Access Compliance Report Public Rights-of-Way (Curb Ramps)

Intersection ID: 10020275Main Street: AYRSLEY_TOWN_BVCross Street: N/ALocation: NWADA ID: D94610E284D9Ramp Type: PerpInitial Pass/Fail: FailOverall Compliance: NoSeverity Score: 12.5

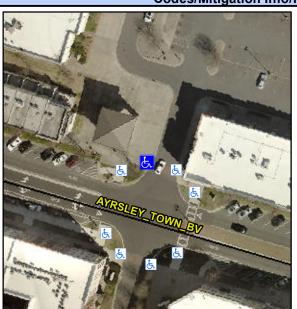
| Possible Solution | | Field Measurements/Component Compnance | | | | | | |
|------------------------------|------------|--|-----------------------|-------|-----------|---------------------------|--|--|
| Remove & Replace Entire Ramp |) . | N/A | Ramp Length (in) | 95.0 | No Ra | amp Slope (%) | | |
| R304.2.2 | | N/A | Gutter Lip Ht (in) | N/A | N/A G | utter X Slope (%) | | |

| Possible Solution | | Field Measurements/Component Compnance | | | | | | |
|------------------------------|------------|--|-----------------------|-------|-----------|---------------------------|--|--|
| Possible Solutions: | | Comp | liance Description | Data | Compliand | e Description | | |
